FINAL  
ENVIRONMENTAL IMPACT STATEMENT  
USDA-SCS-ES-WS-(ADM)-74-13-(F)  
LEONA RIVER WATERSHED  
PROJECT

Uvalde County, Texas

FINAL ENVIRONMENTAL IMPACT STATEMENT

September 1974

Figure 1  
SECTION OF A TYPICAL FLOODWATER RETARDING STRUCTURE

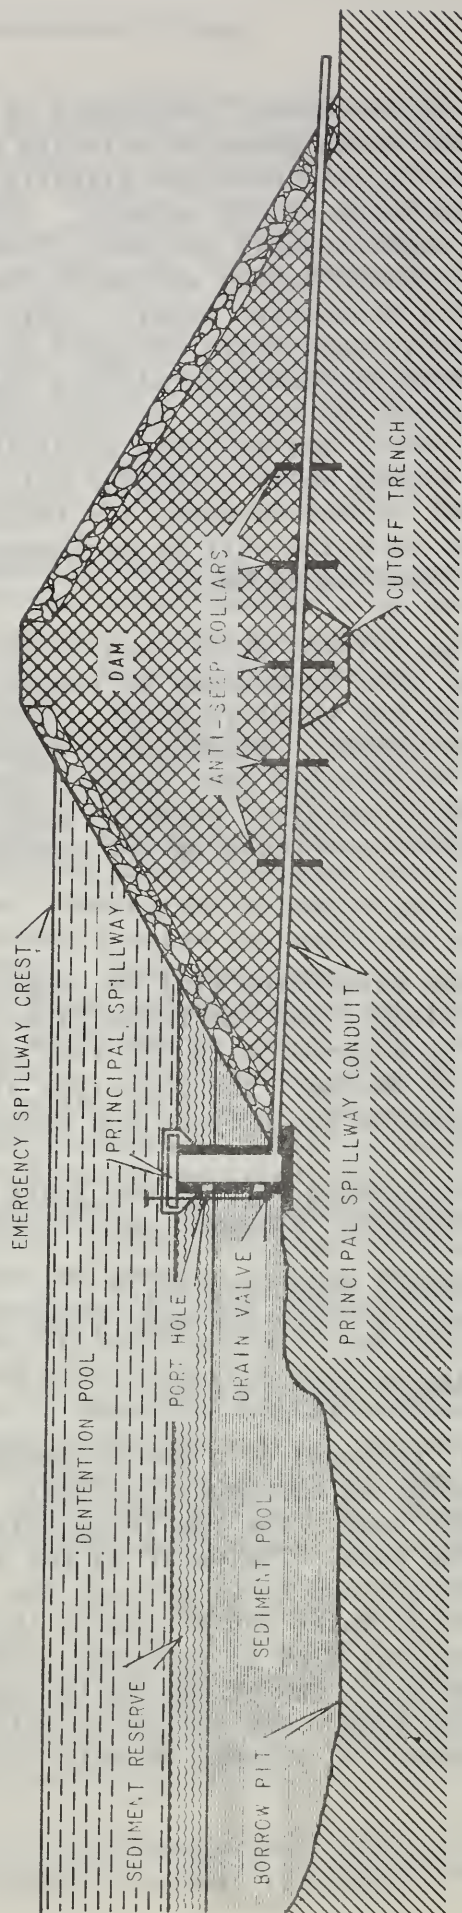
- Comment: The Department stated, "The project description as now presented is only partially adequate because it does not fully describe what structural measures will be built. The fourth paragraph on page 15 (of the draft environmental statement) obliquely refers to embankments, but it would be better to fully describe the embankments in the second paragraph. Also, figures 2 and 3 from the work plan might be added to the environmental statement to enhance the project map in Appendix C."

The project description as now presented is only partially adequate because it does not fully describe what structural measures will be built. The fourth paragraph on page 15 obliquely refers to embankments, but it would be better to fully describe the embankments in the second paragraph. Also, Figures 2 and 3 from the work plan might be added to the environmental statement to enhance the project map in appendix C. On page 15 the third paragraph under structural measures is unclear in that if structure No. 3 must be ported within a 200 acre-foot limitation as prescribed by the State water rights law, why is it permissible to port structures Nos. 1, 2, and 4 at the 50-year sediment

- Response: The narrative in the PLANNED PROJECT section has been revised and additional information added to describe more precisely the structural measures to be constructed. A section of a typical floodwater retarding structure has been included in the Planned Project section as Figure 1.
